Project No. 21482114

**RESPONSE TO GEOTECHNICAL PEER REVIEW COMMENTS FROM GEMTEC
PROPOSED RESIDENTIAL DEVELOPMENT
3930 AND 3960 RIVERSIDE DRIVE, OTTAWA, ONTARIO**

A geotechnical peer review was completed by GEMTEC on behalf of the City of Ottawa and the relevant comments were provided in GEMTEC Letter no. 100008.025 – Rev0, dated Dec 7, 2023. The comments are noted below with response from WSP.

PROJECT NO. 21482114 CONTROL 0005 REV. 0 FIGURE 1

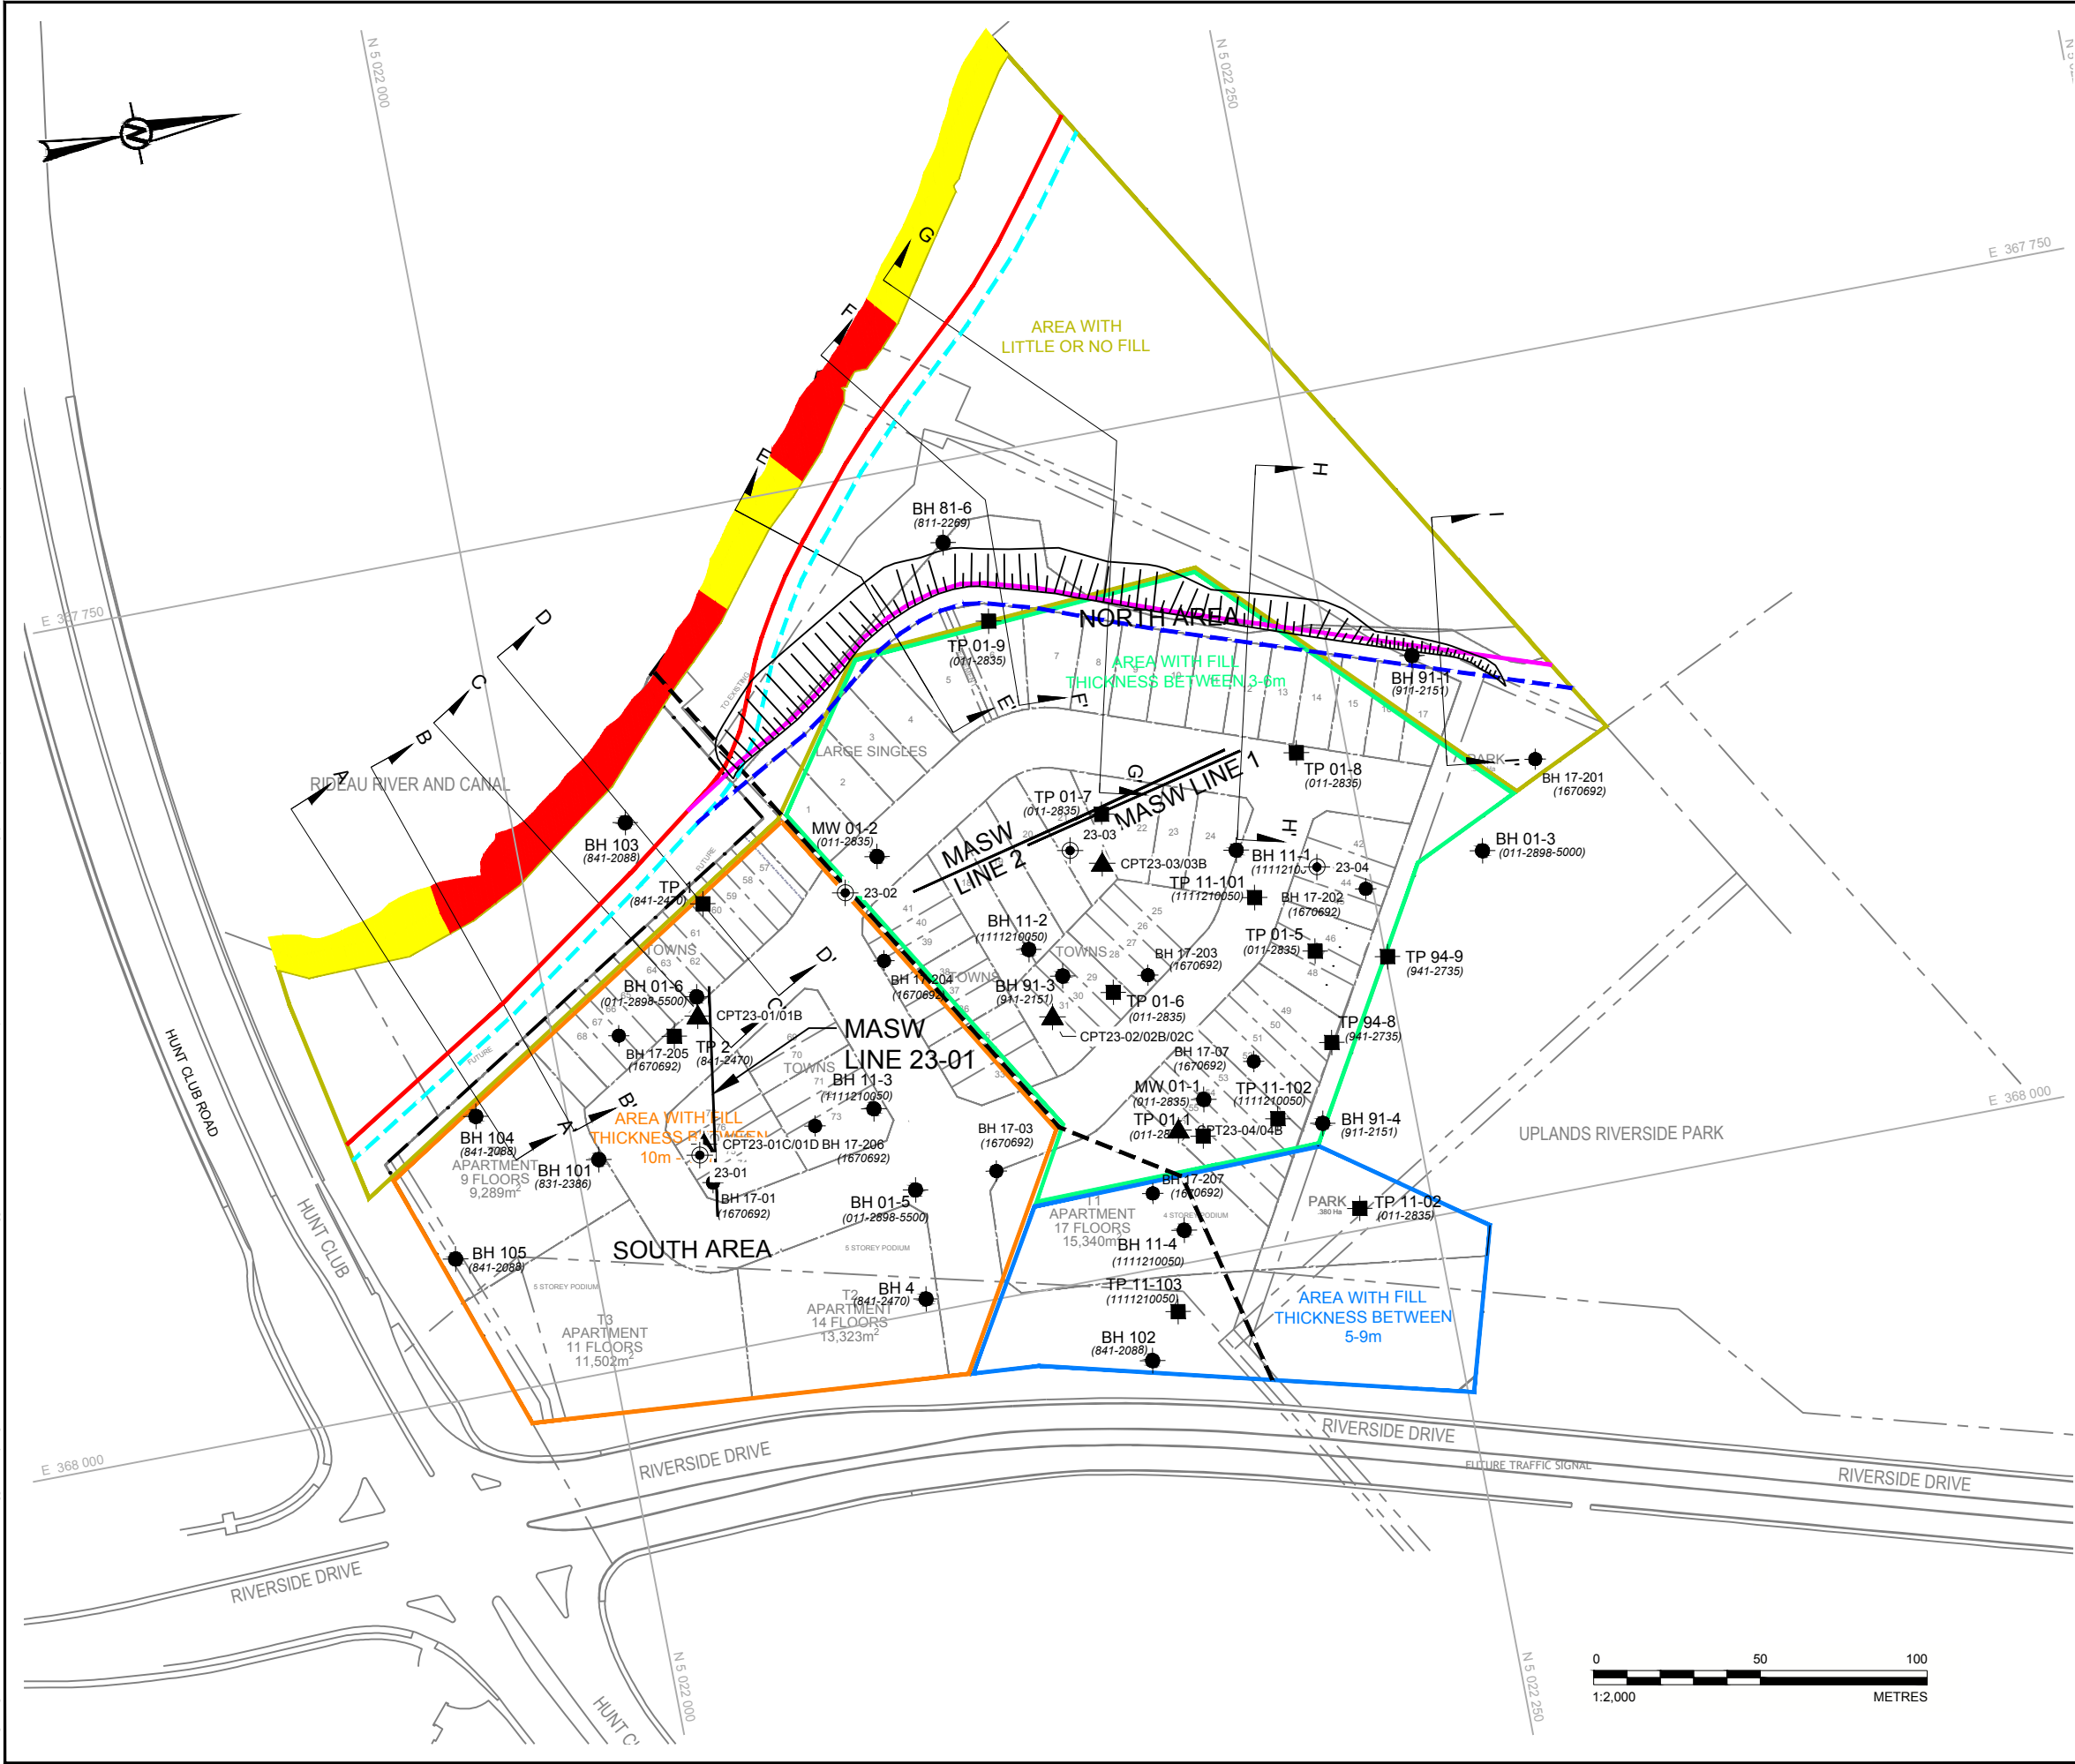
- 1) "The site plan in the report (i.e., Figure 1) indicates the locations for the following test pits or borehole but the records do not seem to be included in the report.
 - Testpits 1 to 17 (Project No. 011-2898);
 - Testpits 94-15 and 94-18 (Project No. 941-2135);
 - Testpits ST-1A, ST-1B, ST-1C, ST-2A, ST-2C (Project No. 1111210050); and,
 - Boreholes 3, 5, and 6 (Project No. 841-2470)"

- 2) "In addition, the following was also noted with respect to the testhole records and site plan:
 - TP 11-102 (011-2835) and TP 11-02 (1111210050) seem to be mis-labelled; and,
 - There appears to be an unlabelled testpit marker in the area between BH 91-3, CPT23-02/02B/02C, and 17-203 (approximately in the middle of the site)."

- 3) "The MASW testing was carried out within the North Area, where the fill thicknesses are significantly less than in the South Area (i.e., 6 to 7 metres at the MASW lines versus up to 20 m thickness in the South Area). Due to the significant difference in stratigraphy, it is not clear that the obtained shear wave velocity values are representative within the South Area or that the interpreted Site Class D based on those values is also applicable for the South Area. "

Response - *The above noted records could not be located in our archives and have therefore not been included in the report. The locations of these boreholes and test pits have also been removed from the site plan for clarity.*

Response - *The above has been corrected on the site plan.*

Response – *Additional MASW testing within the South Area was carried out by Conetec on 2 March 2023 (See Appendix G of the WSP report). The results are consistent with a Site Class D. This MASW line has now been added to the Site Plan (Figure 1).*

Title: Cross Section A-A
File Name: 21482114_Section A-A_1m higher_MG.gsz
Name: Static Drained
Method: Morgenstern-Price
Horz Seismic Coef.: 0

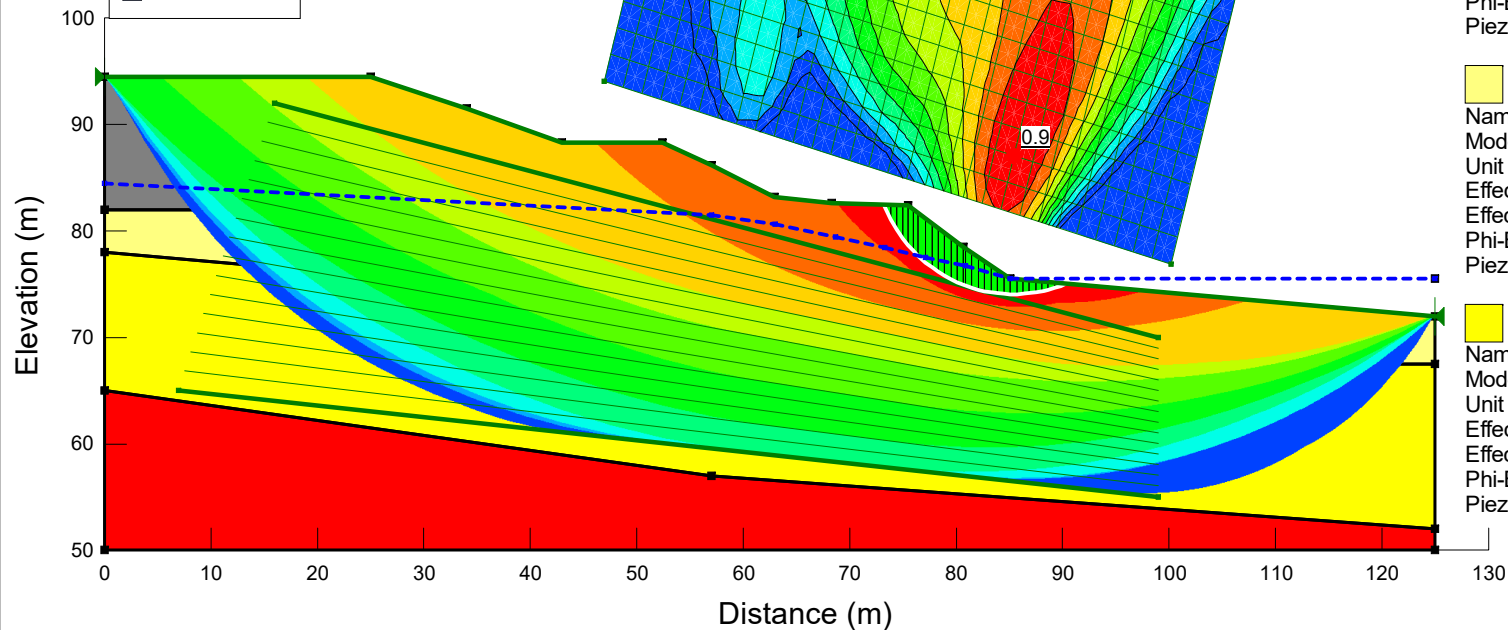
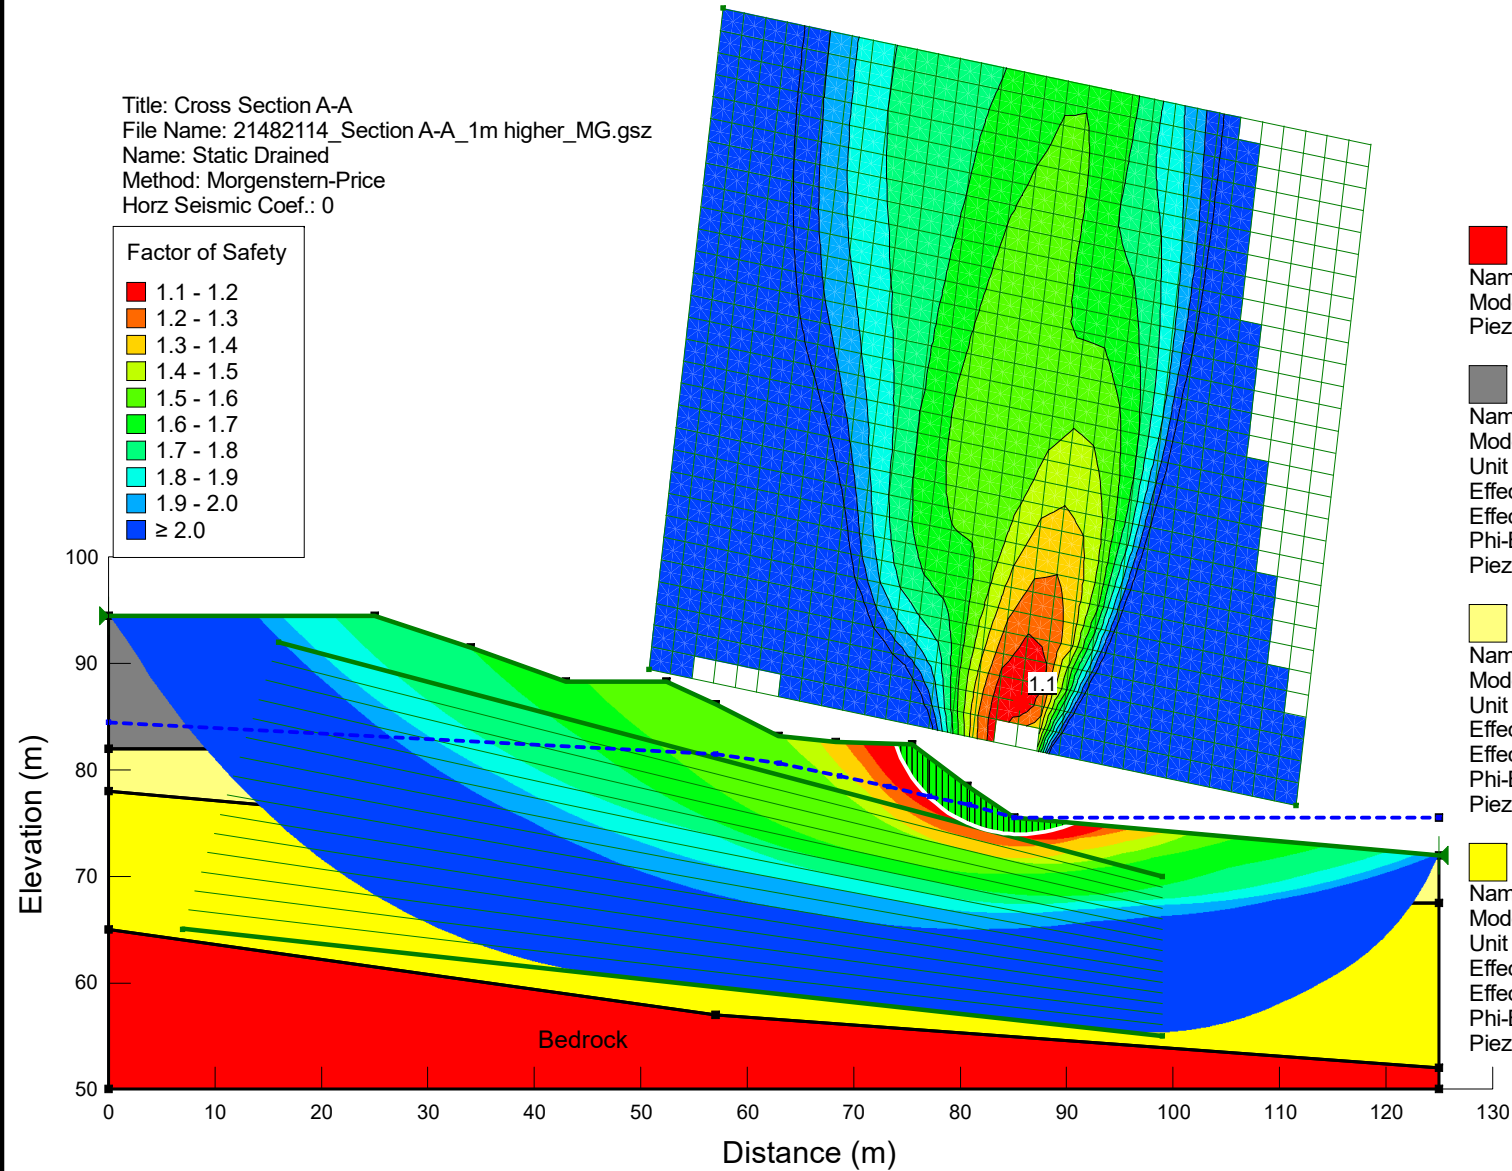
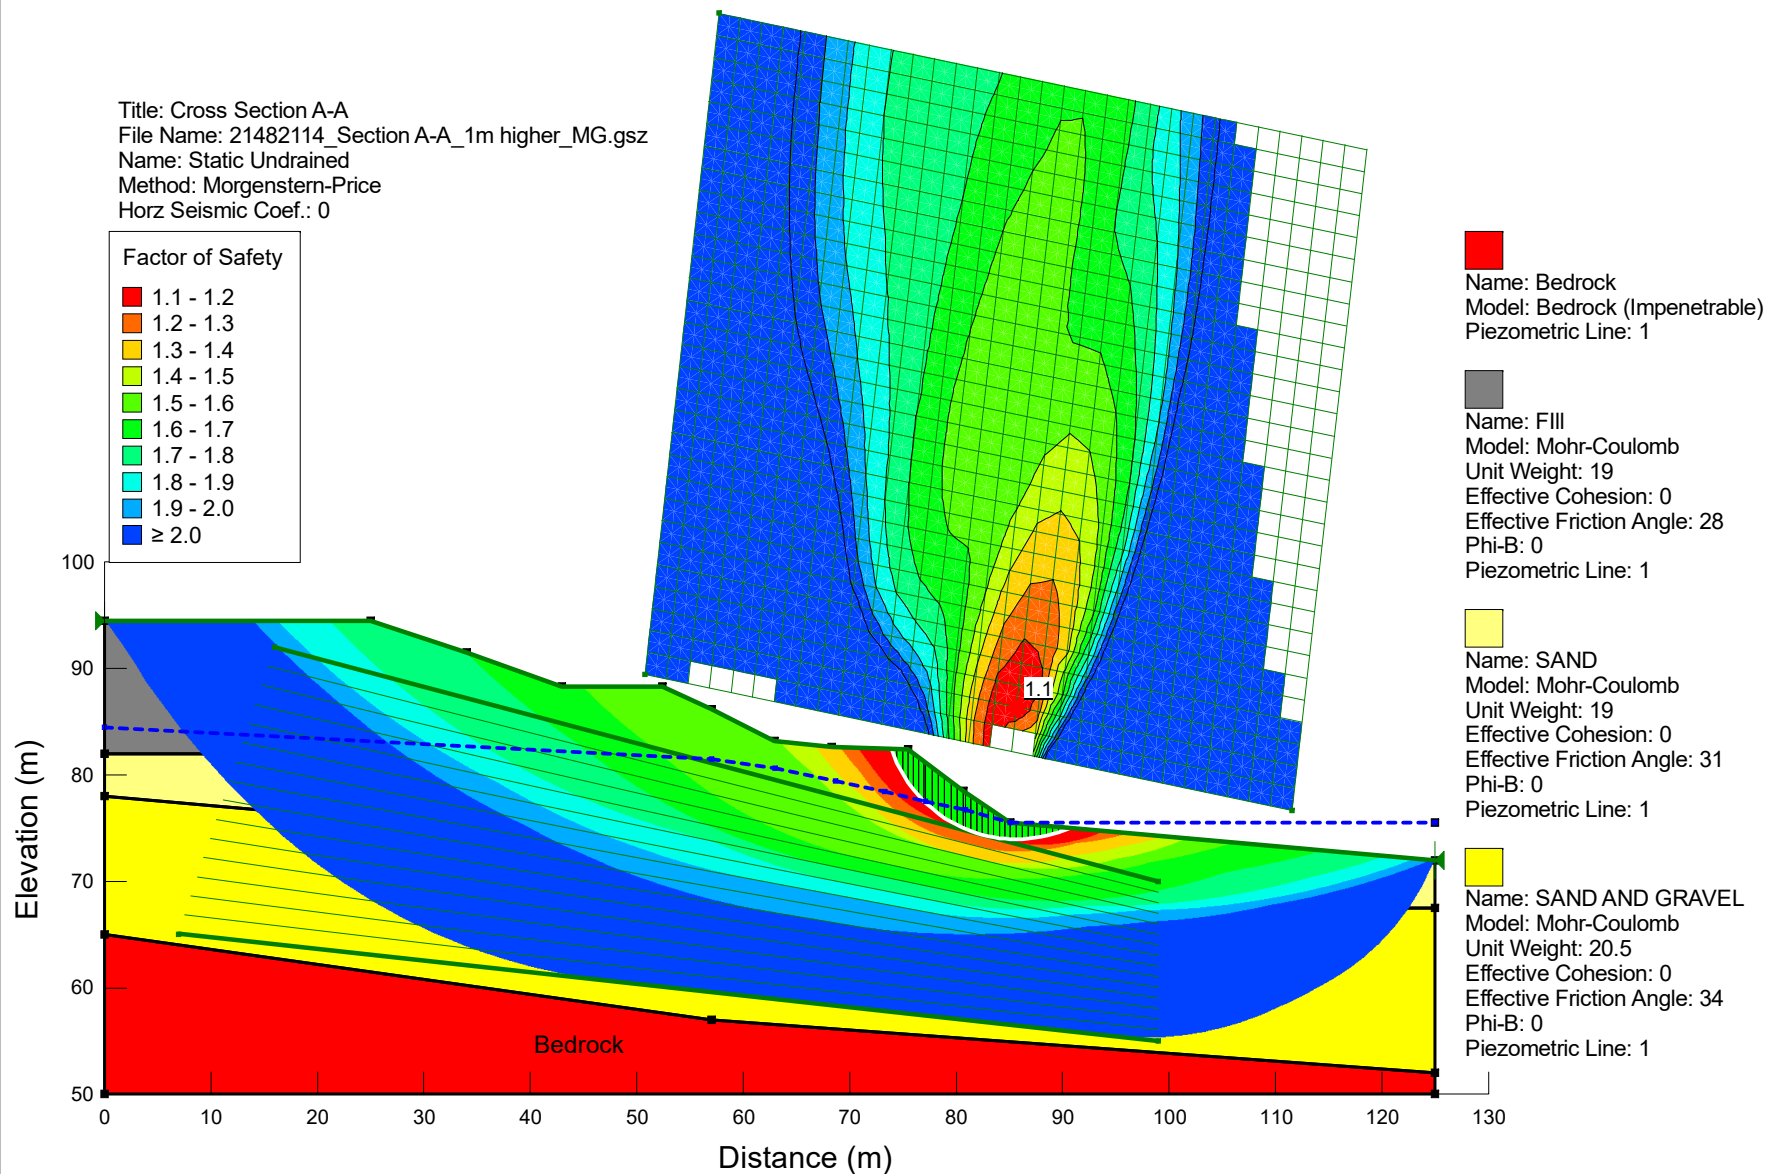
- 4) “The following comments are provided for the slope stability analysis carried out for Sections A-A', B-B', C-C', and D-D'. The safety map for the static and seismic analyses for the values of less than 1.5 and 1.1 respectively, extends past the upper edge of the point grid (for the slip circle centre), which may indicate there are slip circles with those factors of safety or less that extend horizontally farther than currently shown. This could potentially result in an increased stable slope allowance, and it is suggested that the model geometry be revised (by extending the point grid) to check the limits.”

- 5) “The groundwater level assumed in the static analyses for the South Area is at the base of the existing fill (i.e., at elevations of about 82 to 83 m) and is indicated to be based on the water levels measured in the various monitoring wells at the site. This would be Case 3 as outlined in the slope stability guidelines and may not be a realistic assumption. The fill materials above the native sands are not uniform in composition and contain cohesive layers and materials with high silt and clay contents that will tend to retain water and therefore it may not be reasonably conservative to assume the fill materials are fully drained as assumed in the slope stability analyses. The water levels summary in Section 4.1 of the report notes that: “In the South Area, the groundwater level was generally found to be between 12 to 16 m depth (i.e., between elevations of about 75 to 83 m), but as shallow as about 6 m (i.e., elevation of about 88 m).”

Response – *The models for the sections identified above were revised (by extending the point grid), no differences have been observed in the stable slope allowance.*

Response – *While the water level in the south area was recorded to be between elevations of 75.1 and 87.6 m (in monitoring wells as well as from CPT Dissipation testing), it was generally found to be below elevation of 79 m. Only one single borehole location had a higher water level of 87.6. We therefore feel that the original assumptions regarding groundwater level are reasonable assumptions for the overall groundwater depth in the area of interest. Nonetheless, as a precautionary measure and an additional check, the slope stability models for these four sections were revised to take into account for the possibility of a higher groundwater level in South Area by adjusting the piezometric line in the analysis upward in the east side of the site (where the single high level was recorded). This adjustment results in a very minor change to the slope stability (well within the margin of error of the data and assumptions which go into the analysis). The change is of sufficiently small magnitude as to make no meaningful difference to recommended stable slope allowance, and therefore we feel that the originally recommended setbacks may be maintained. The results of the revised slope stability analysis are attached to this memorandum.*
